Bent Grass East Commercial  
Filing No. 3  
Updated Traffic Impact Analysis  
PCD File No. SP2010  
(LSC #204660)  
March 5, 2021

LSC Responses to  
EPC TIS Redlines <sup>1</sup>

# LSC Responses to EPC TIS Redline Comments

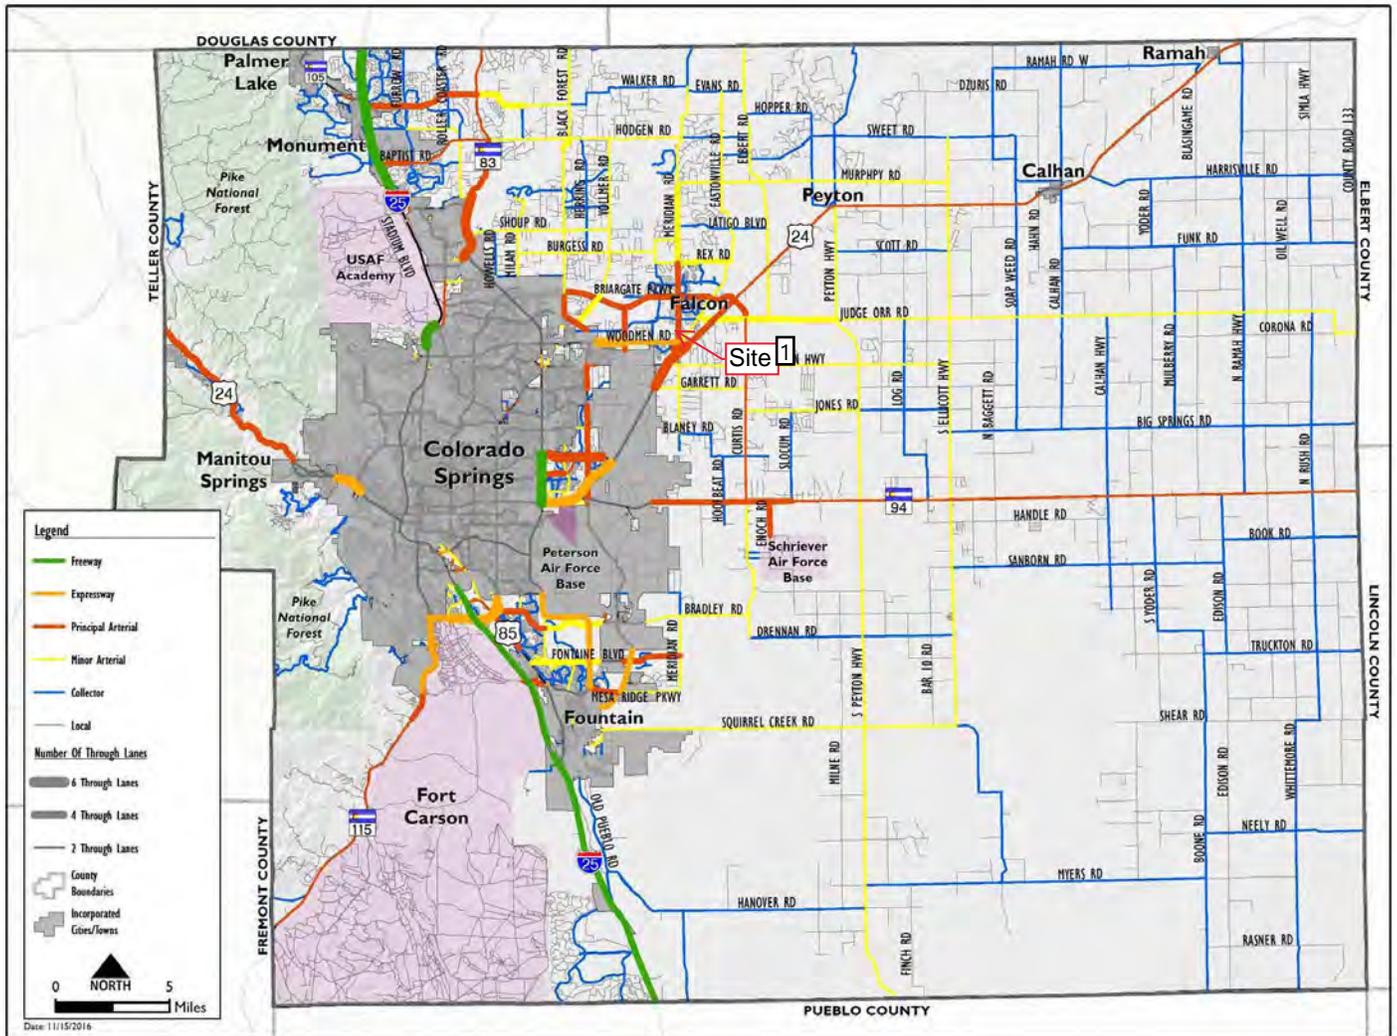
The ADT for Meridian Park Drive is greater than the design ADT for an urban local roadway. It appears that the classification of Meridian Park Drive should be upgraded to an urban non-residential collector. Also, with the closing of the northerly 7-eleven access, the additional traffic turning left into 7 eleven from meridian Park may conflict with the left turns from the private road onto Meridian Park Drive. Please address in the report.

*The ADT for Meridian Park Drive is greater than the design ADT for an urban local roadway. It appears that the classification of Meridian Park Drive should be upgraded to an urban non-residential collector.*

*Also, with the closing of the northerly 7-eleven access, the additional traffic turning left into 7 eleven from meridian Park may conflict with the left turns from the private road onto Meridian Park Drive. Please address in the report.*

LSC Response: Meridian Park Dr is not identified on the 2016 El Paso County Major Transportation Corridors Plan (MTCP). This roadway was approved and constructed as a Local with the development of the Bent Grass Commercial PUD. The land use currently proposed is consistent with the land use shown at the time the PUD was approved.

Meridian Park Drive ADT shown in the TIS report includes previously estimated potential commercial development associated with the Owl Place area. Meridian Park Drive was required by EPC to extent to the south property line to allow for possible future access to the Owl lane area and potentially a connection between [now] Falcon Marketplace and the south end of Meridian Park Drive. This was required to ensure access management on Meridian Road as no full movement would be allowed between Eastonville and Bent Grass Meadows Drive. This connection was basically intended as a commercial "local frontage road" for the relatively short distance between Eastonville and Bent Grass Meadows Drive.

Meridian Park drive was constructed with sufficient width to stripe a two-way, center left turn lane if ever needed. This roadway should be classified as a "Local" Roadway – not a "residential local" roadway with individual residential lot access, on street parking, etc., rather a "commercial local" roadway, where access to adjacent parcels is the predominant function. A significant portion of the ADT is due to Owl Lane redevelopment trip estimates from 10-15 years ago. Commercial development of the size and configuration that was common at that time likely no longer applies today for the owl lane area, and any commercial development would likely be significantly smaller and generate significantly fewer trips.

LSC Response: The TIS report assumes all 7 Eleven traffic utilizing the south access on Meridian Park Drive, therefore, the level of service analysis takes into account the additional conflicting vehicles at this intersection and the associated additional delay for the eastbound left turn from the private road onto NB Meridian Park Drive. The level of service for the eastbound approach is calculated at LOS D. This LOS is based a high northbound through volume on Meridian Park Drive from a prior projection of potential future trips from the Owl Lane area if redeveloped. Please refer to the response to the above comment.
